**Addendum  
No. 4**

Addendum Date: July 10, 2023  
Project: Admin Building HVAC Replacement  
DeIDOT Administration Building  
SJ Project No: 19121

SHEET TITLE  
**FIRST FLOOR NEW WORK PLAN - AREA A**  
**BIDDING DOCUMENTS**  
 FEBRUARY 14, 2023  
 DRAWN: JD CHKD: PP PROJECT NO. 19121  
 SHEET NO. **E101A**

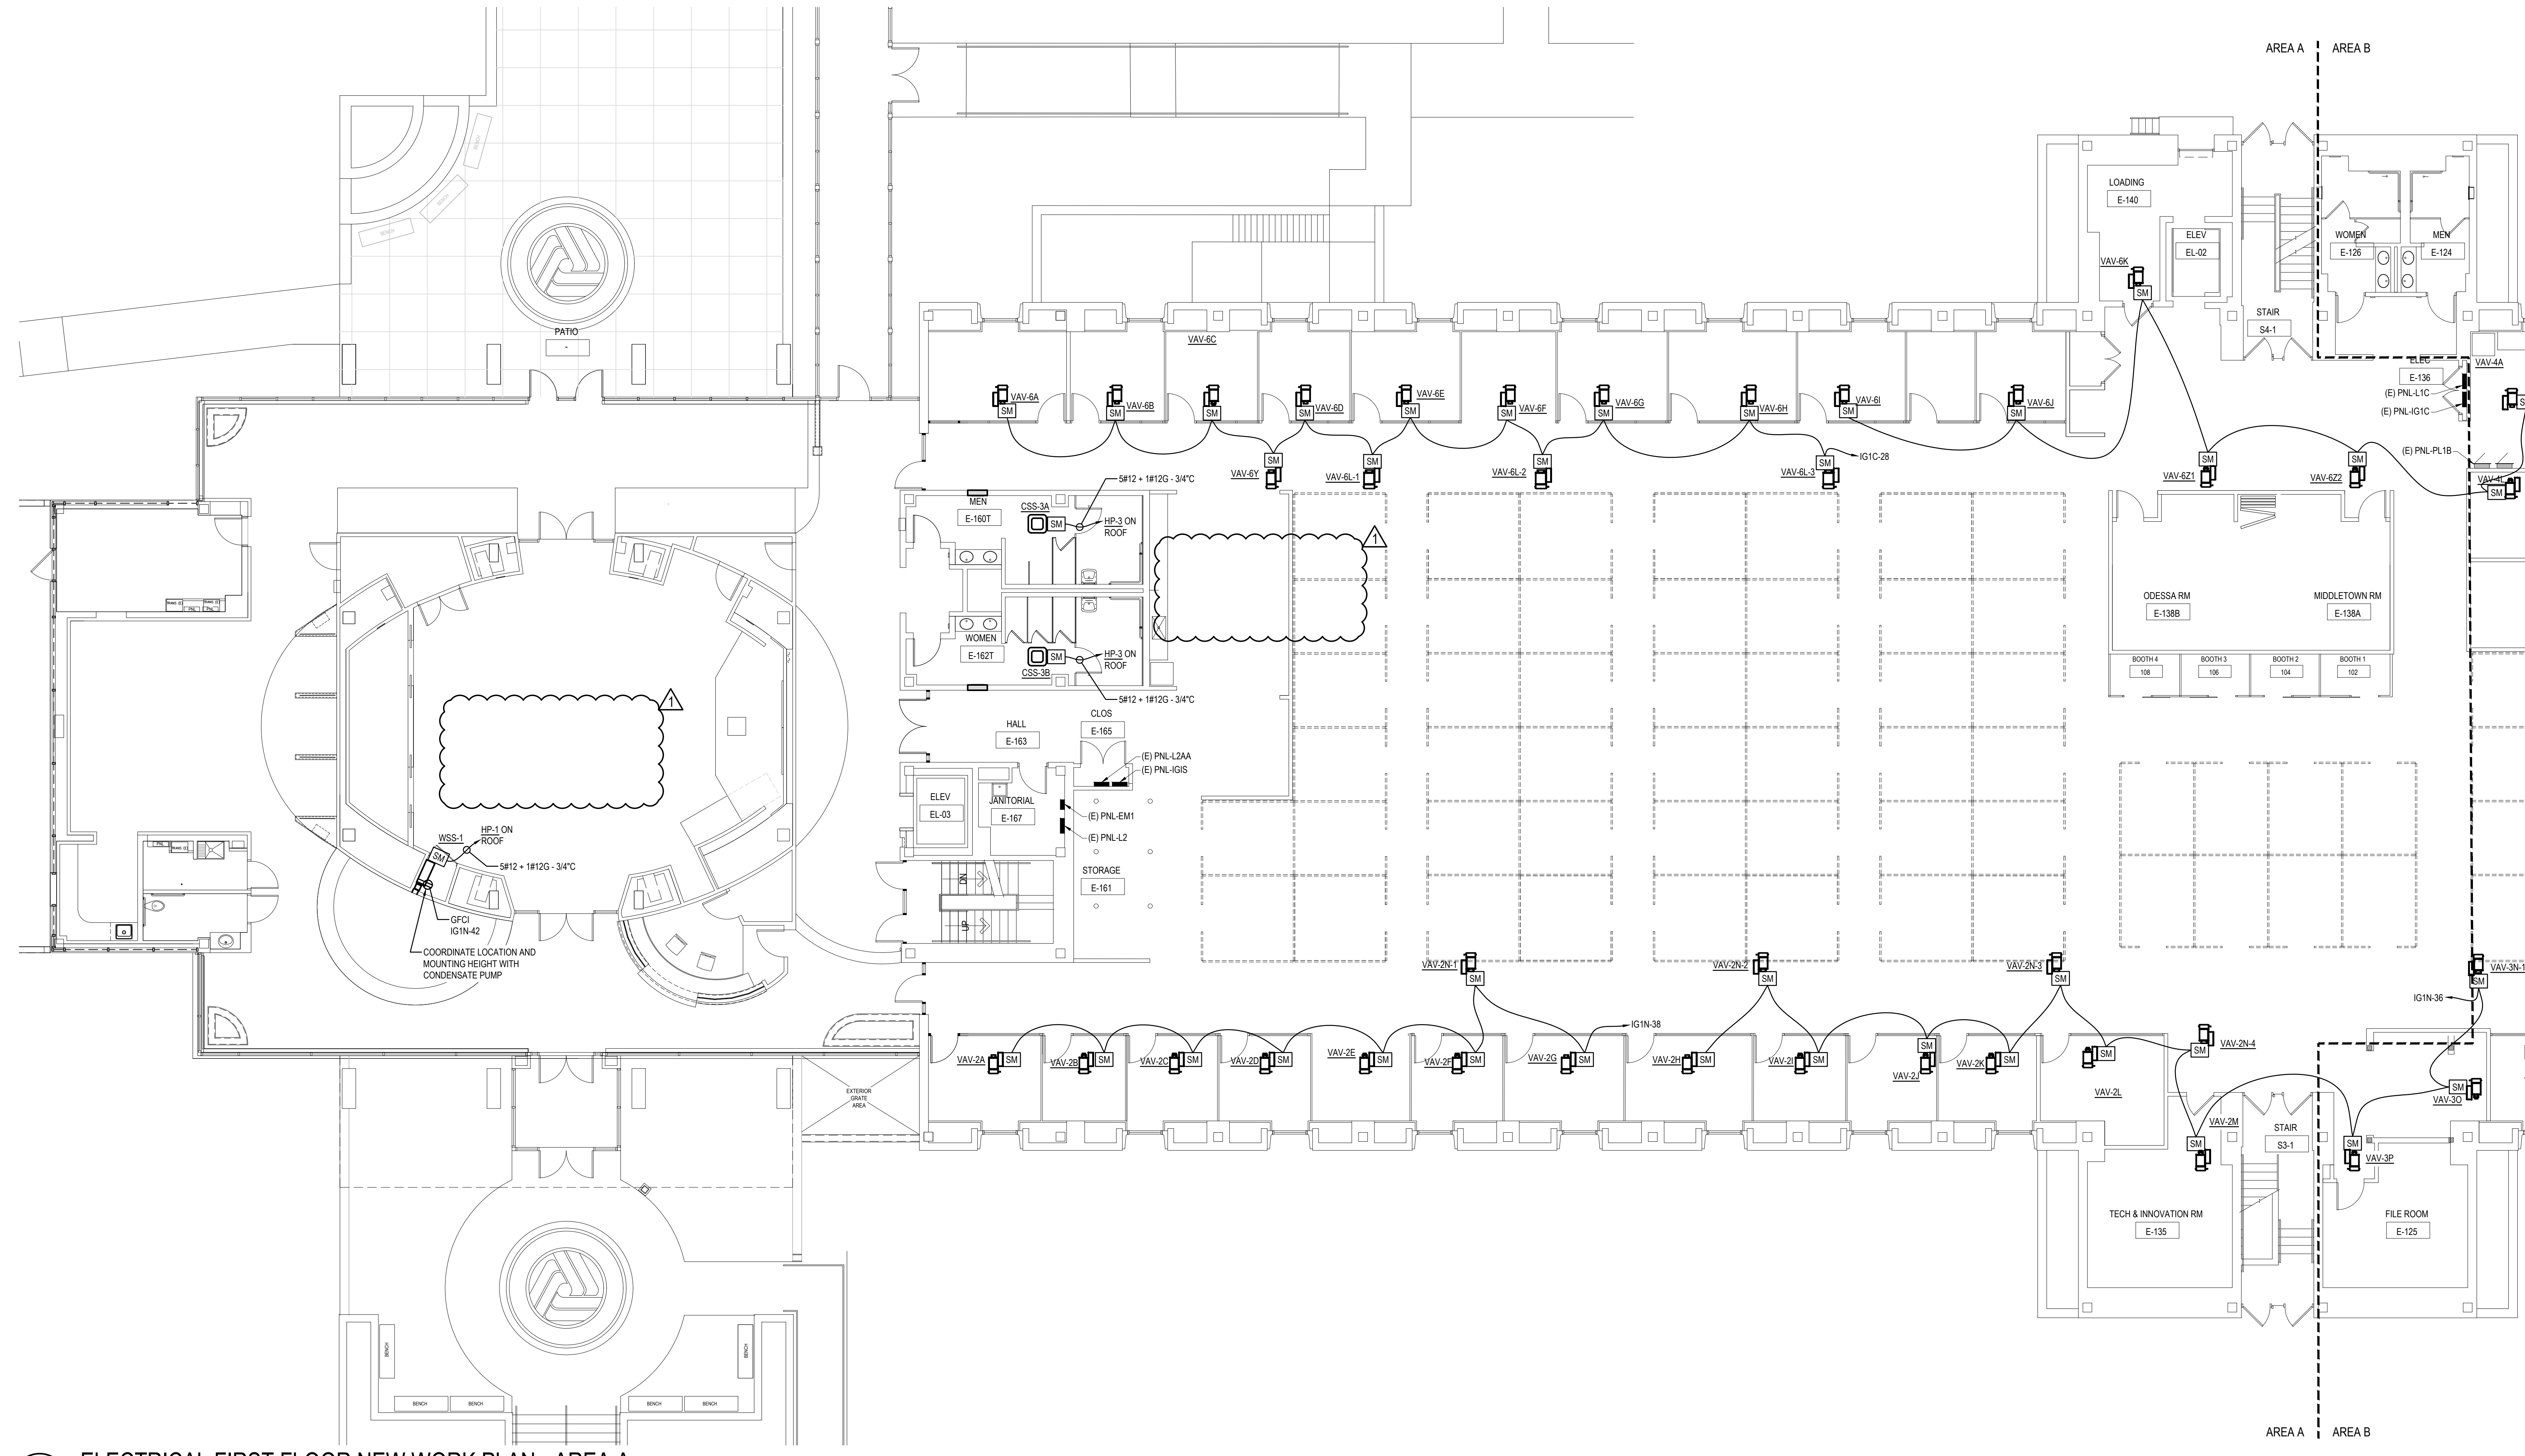
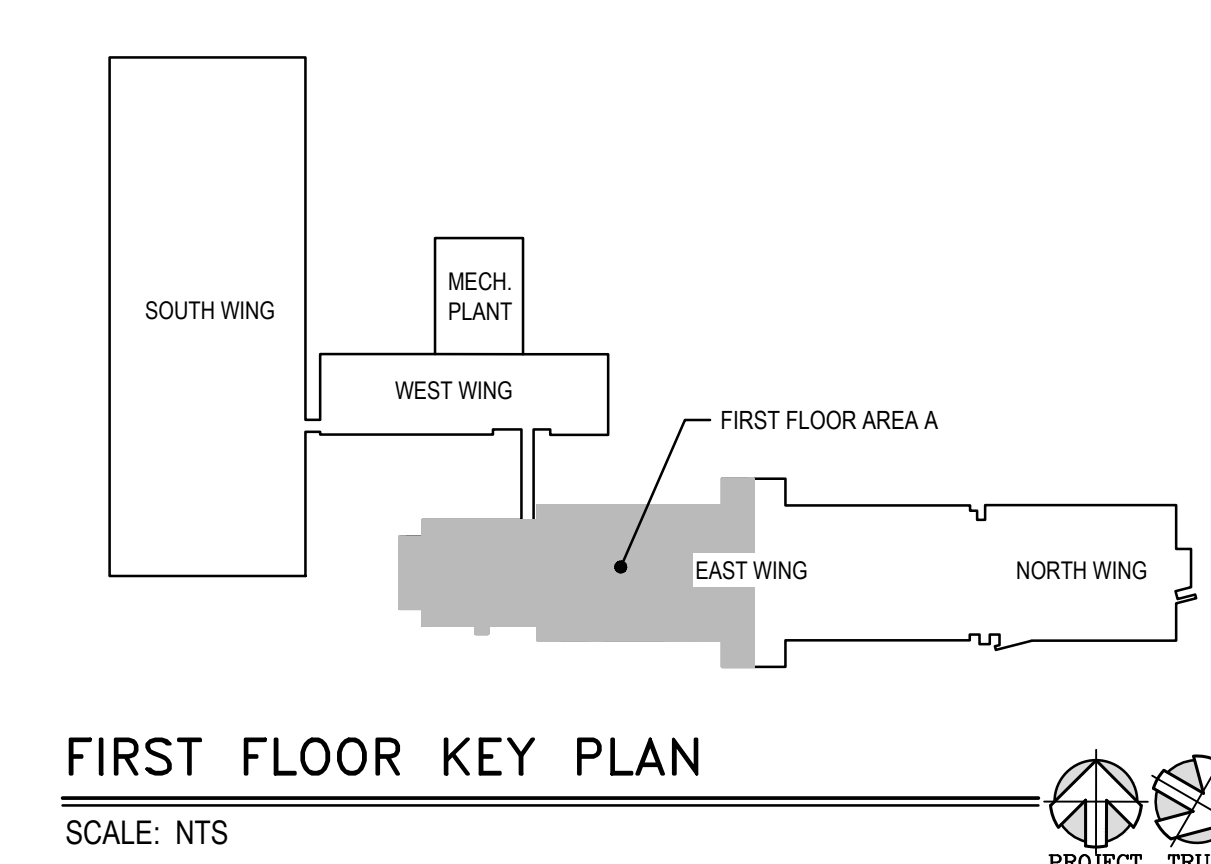
1. Drawing H-103 – Hydronic Roof Plan
  - a. Revise scale from [1/16" = 1'-0"] to [1/8" = 1'-0"].
  - b. No revised drawing issued with addendum, change will be reflected on future drawing issues.
2. Drawing E101A – First Floor New Work Plan – Area A
  - a. Removed rooftop scope of work text box – moved scope to sheet E-103.
3. Drawing E102A – Second Floor New Work Plan – Area A
  - a. Removed rooftop scope of work text box – moved scope to sheet E-103.
4. Drawing E-103 – Roof Electrical Plan
  - a. Added sheet showing rooftop electrical scope.
